Subject: Issuance of Amendment No. 40 to Facility Operating License
No. NPF-11 - La Salle County Station, Unit 1

AMENDMENT NO. 40 TO FACILITY OPERATING LICENSE NO. NPF-11 - LA SALLE, UNIT 1

SUPPORTING AMENDMENT NO. 40 TO FACILITY OPERATING LICENSE NO. NPF-11

LA SALLE COUNTY STATION, UNIT 1

Figure 3.2.1-2

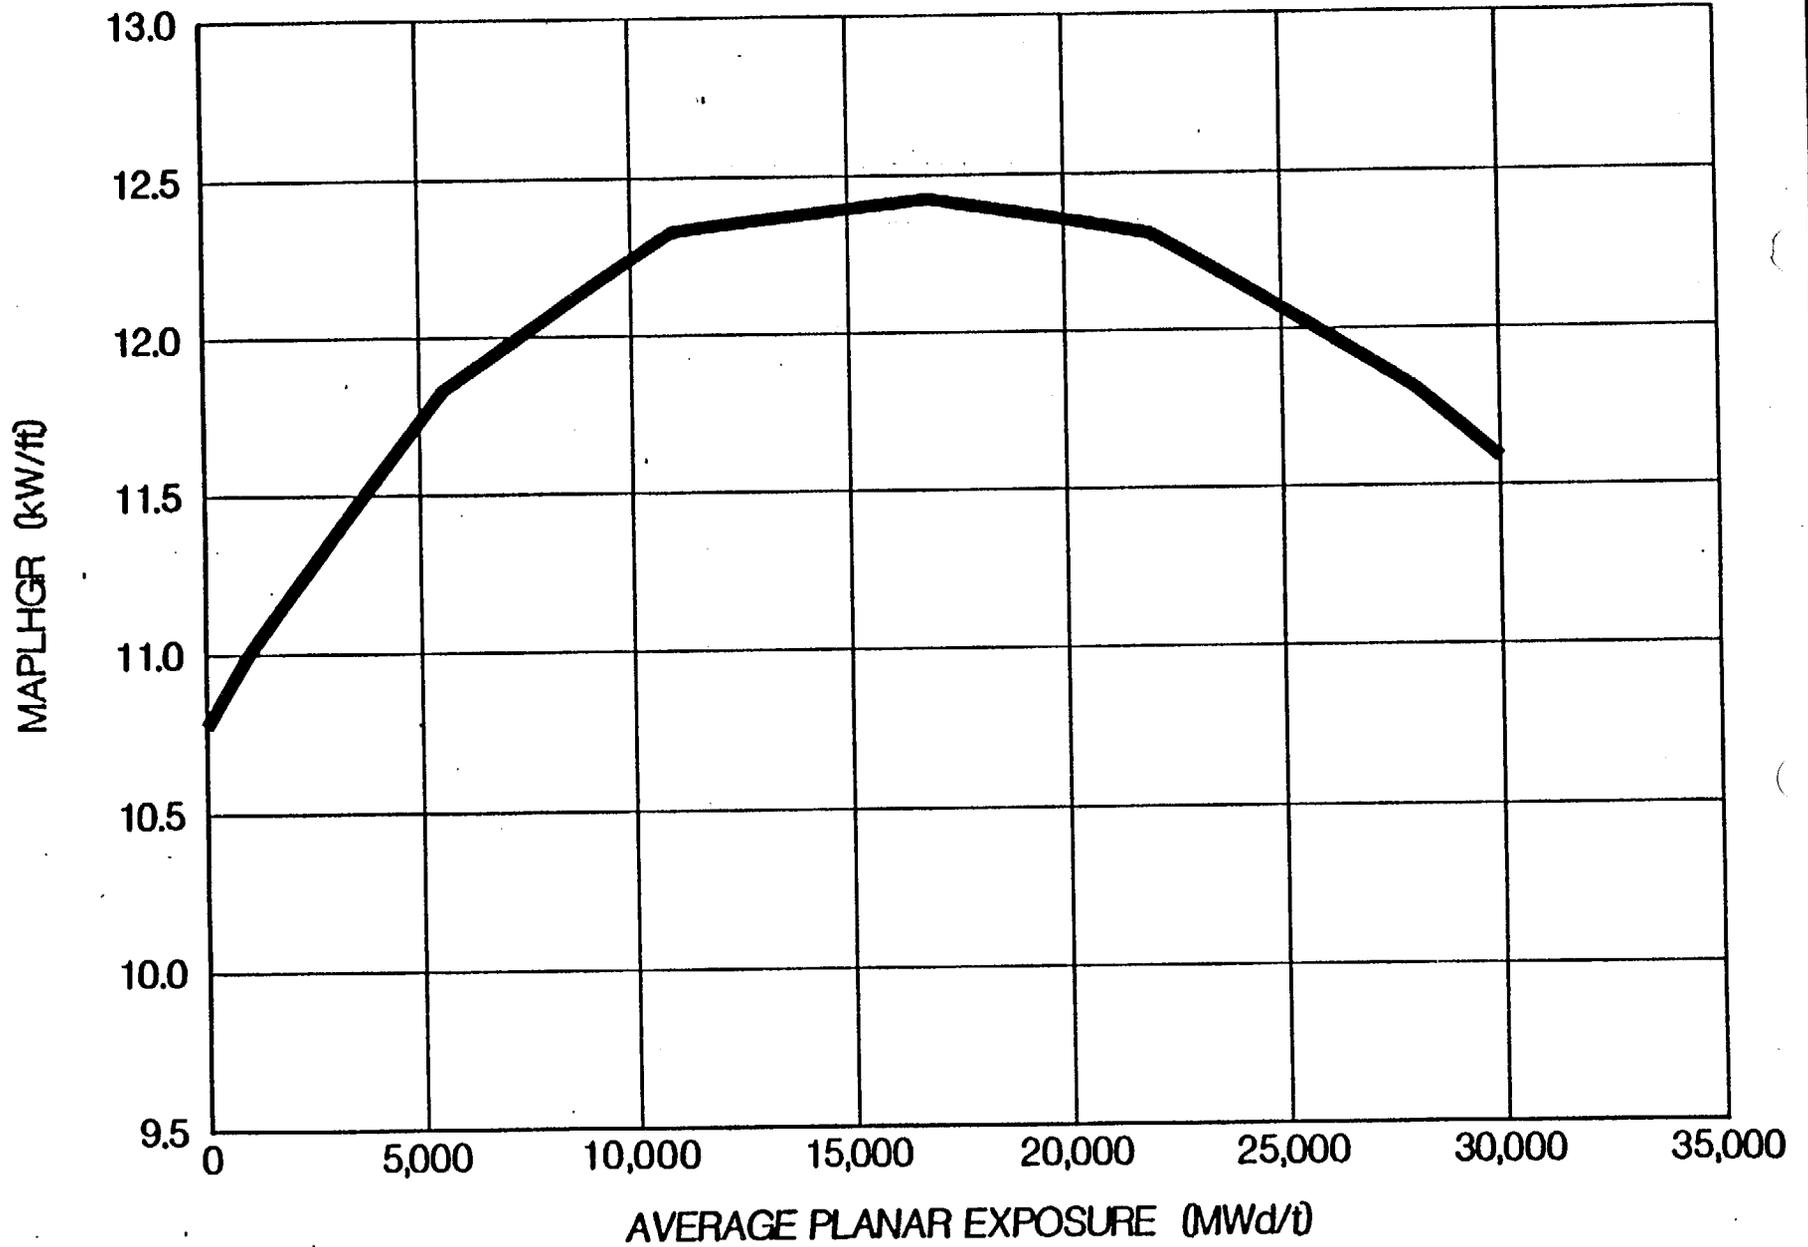
Loss of coolant accident (LOCA) analyses, using approved methodologies and parameters (Reference 4), were performed to provide MAPLHGR values for the new reload fuel assemblies (BP8CR8299L). These analyses and results are acceptable.

Figure 3.2.3-1

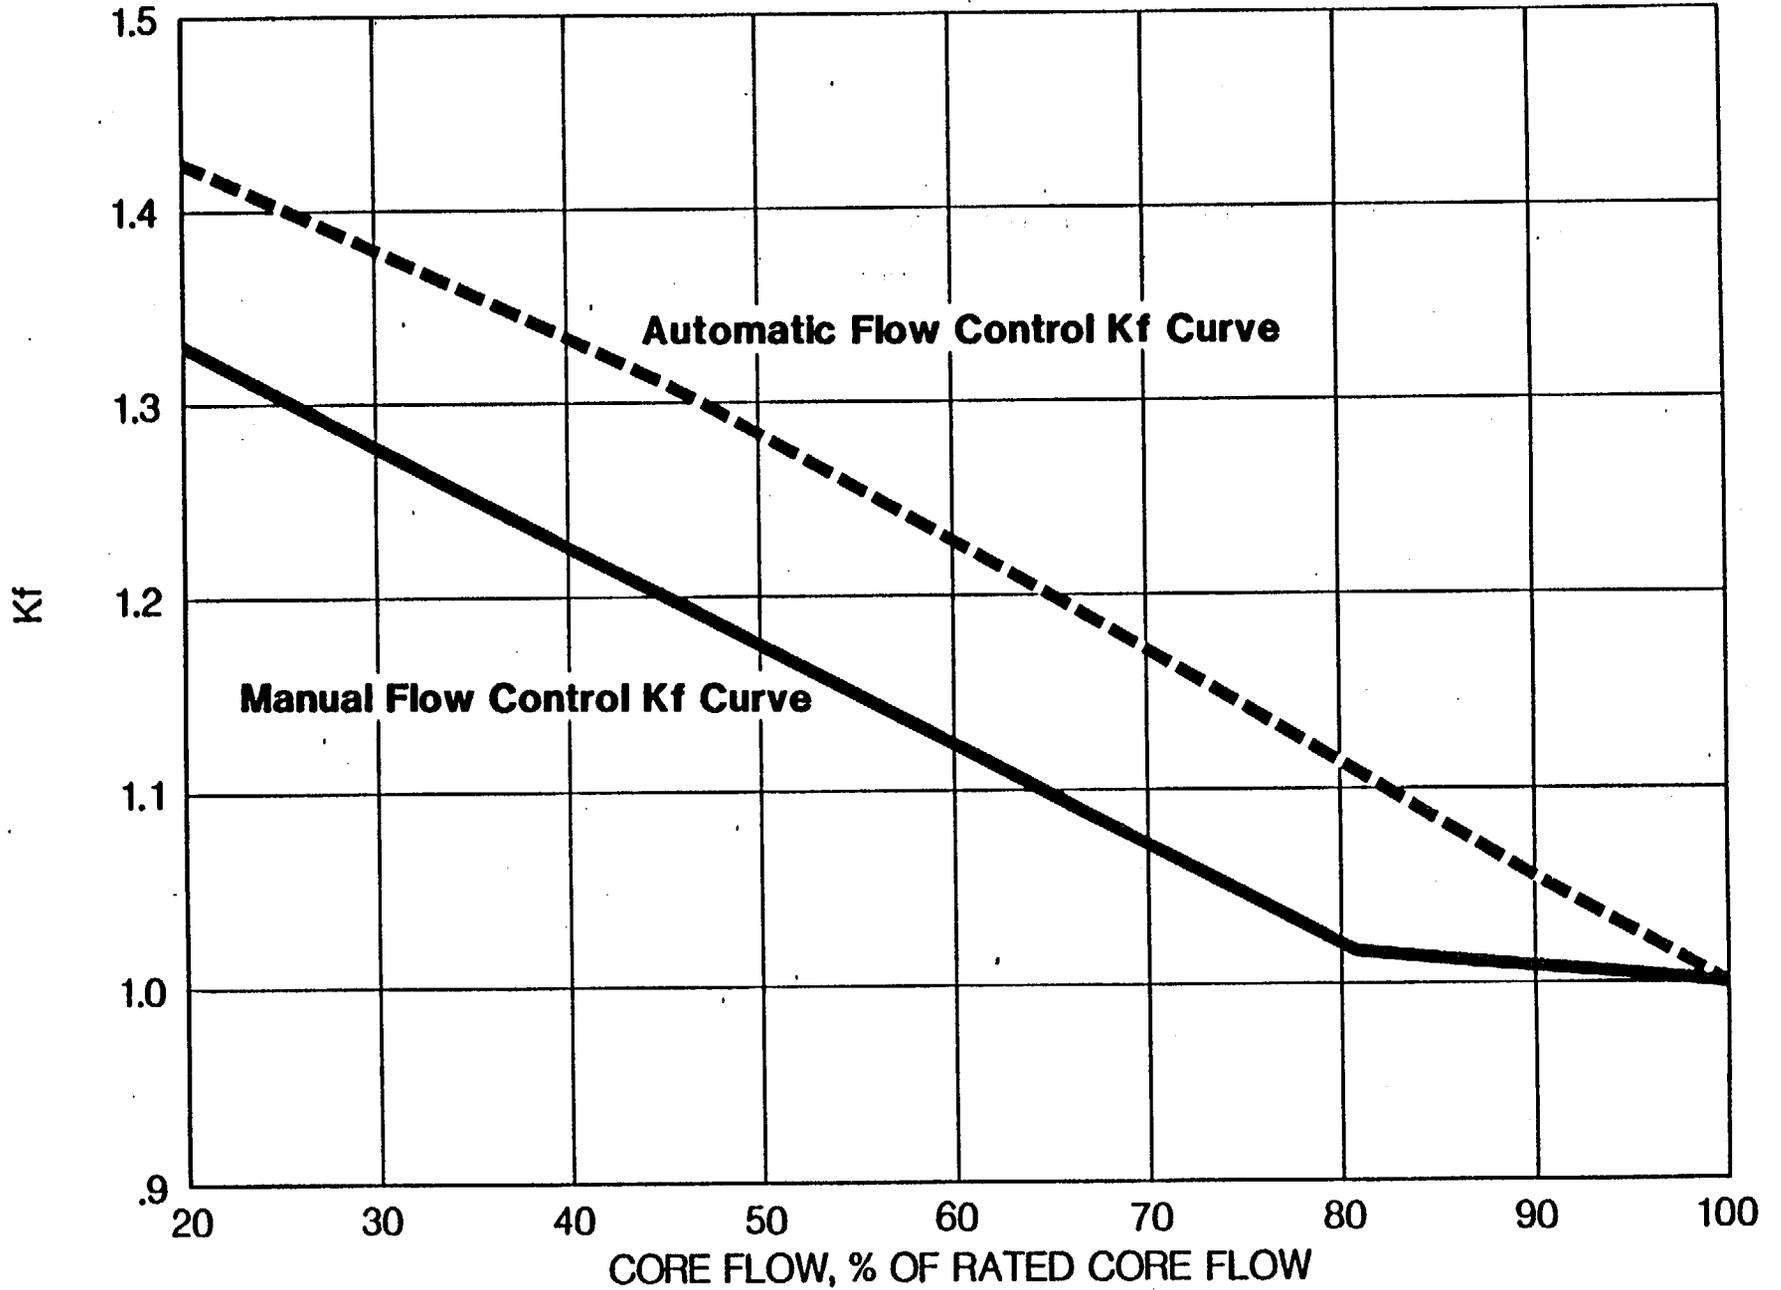
The MCPR vs τ curve is changed to reflect the new transient analyses as previously discussed. The change is acceptable.

Figure 3.4.1.1 -1

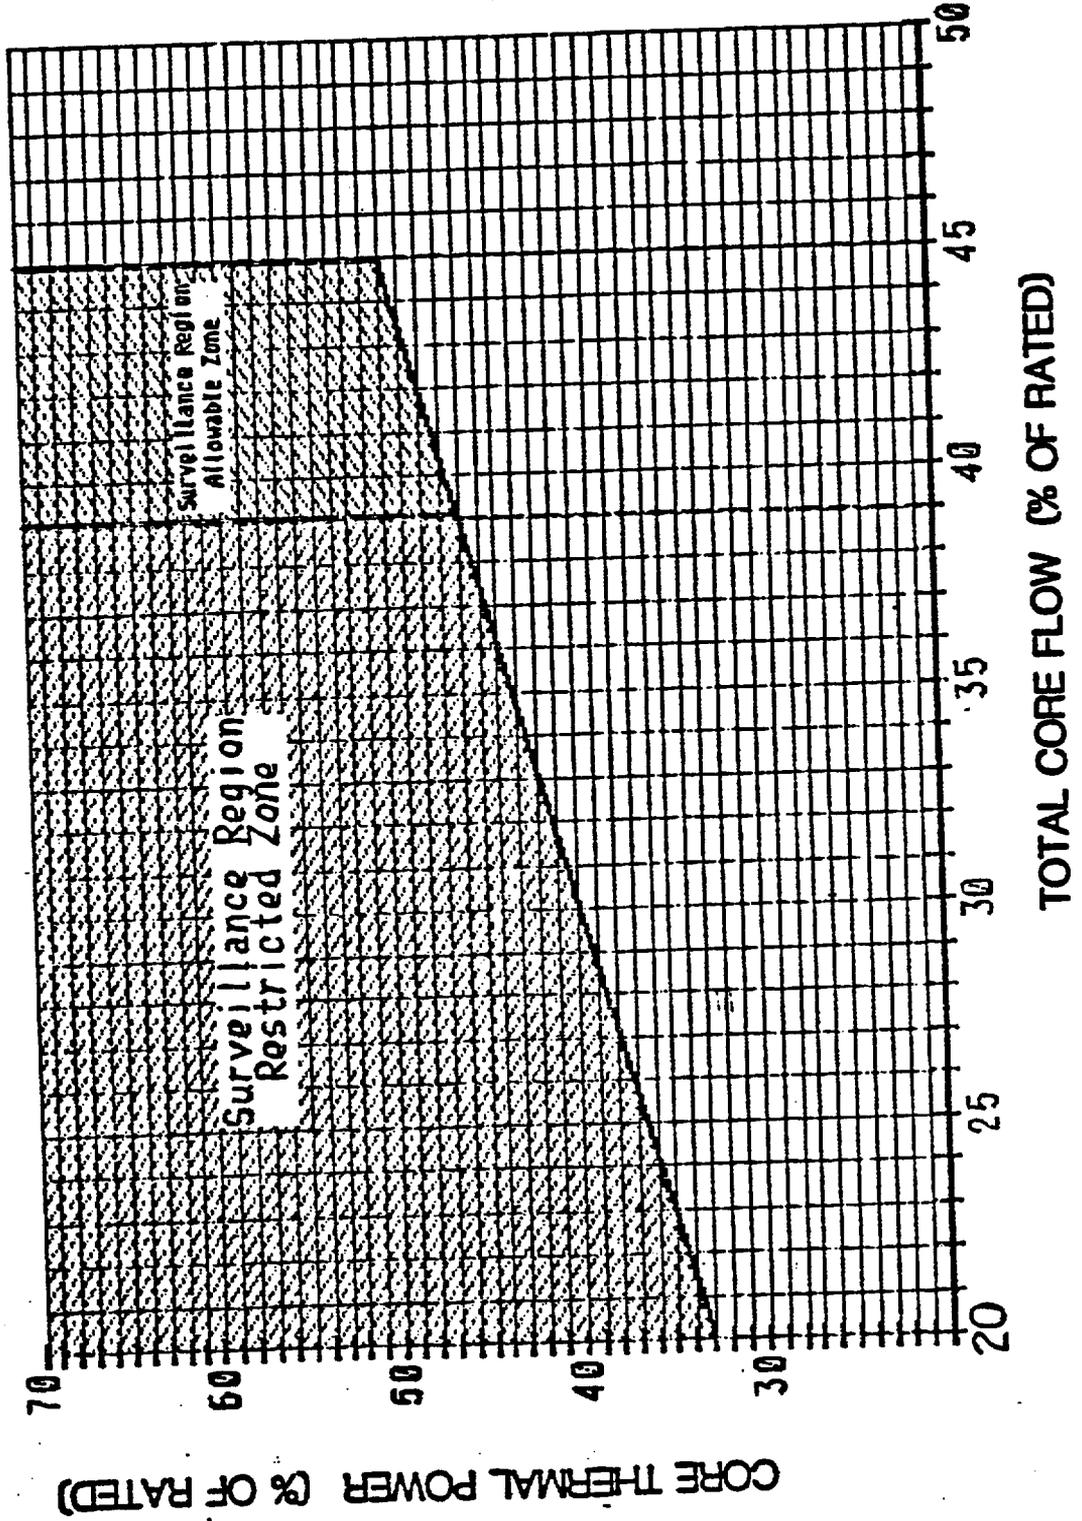
- (a) below 39% flow action must be taken to leave the region and
- (b) above 39% flow and below 45% flow action must be taken to monitor

APRM-LPRM noise and to reduce the noise or leave the region if the noise is greater than 3 times the baseline. They also provide for the establishment of baseline noise levels when entering the surveillance region (if not previously accomplished in the cycle). These action and surveillance requirements (including the LPRM specification) and the times for accomplishing them are comparable to other recently approved specifications and meet the aims of SIL-380. These are acceptable to the staff. Thus, one loop operation is generally acceptable for La Salle without restrictions other than those presented in Specification 3/4.1.1.

These changes are for the Thermal-Hydraulic Stability for single loop operation. They have been discussed in Section 2.6. They are acceptable.
